**EVAPORATION
POND REPAIRS
REV. 1 (1 of 4)**

RE: RESPONSE TO DISAPPROVAL LETTER REPORT
EVAPORATION POND 7 DIKE BREACH AND SUMMARY REPORT EVAPORATION POND
REPAIRS
WESTERN REFINING SOUTHWEST, INC. GALLUP REFINERY
EPA ID # NMD000333211
HWB-WRG-15-006

**Re: Responses to NMED Comments
Summary Report – Evaporation Pond Repairs
Western Gallup Refinery
Gallup, New Mexico**

REVISED SUMMARY REPORT EVAPORATION POND REPAIRS

DRAWING NO. **6b**

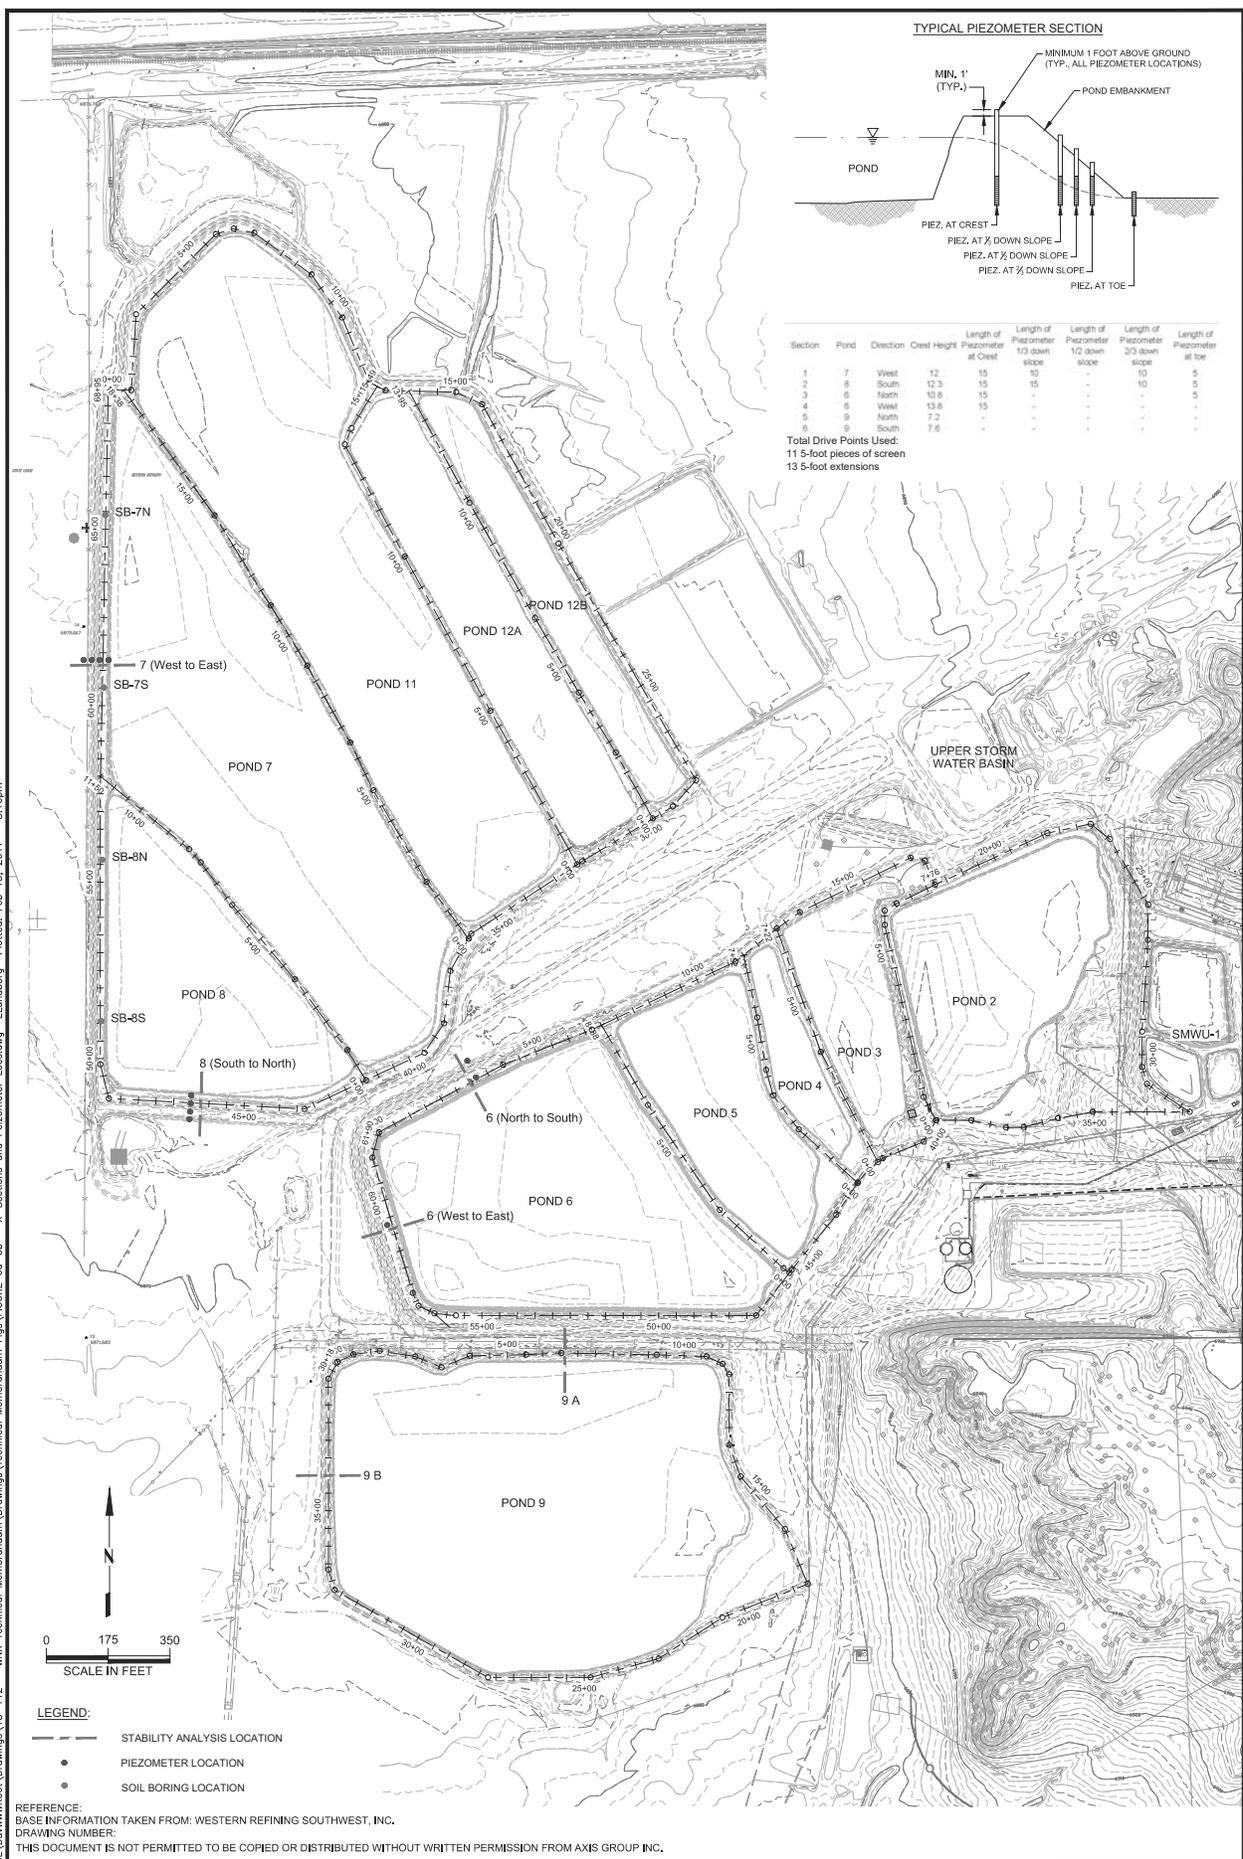
- B:** *Boring logs from 2002 do not contain elevations and no geotechnical lab data were provided concerning the soil material used to complete repairs in 2013 and 2015. The analysis must include this information so that slope stability analyses are accurate and also so that a technical evaluation of the soils geotechnical information may be completed. If historic boring logs do not include elevations and geotechnical laboratory data, then the Permittee must provide a schedule to submit a work plan proposing to collect additional soil boring data.*

Though the boring logs from 2002 engineering report do not contain elevations, the historic topography was discussed in Sections 2 and 3 and shown in cross-sections on Figure 6b of the Report. The geotechnical data for the December 2002 work was provided in Appendix C of the Report. In addition, geotechnical data from the 2013 and 2015 improvement work was provided in Appendix B of the Report. As shown on Table 1 of the Report, the soil properties do not vary greatly for the berm fill throughout the various earth berm sample locations.
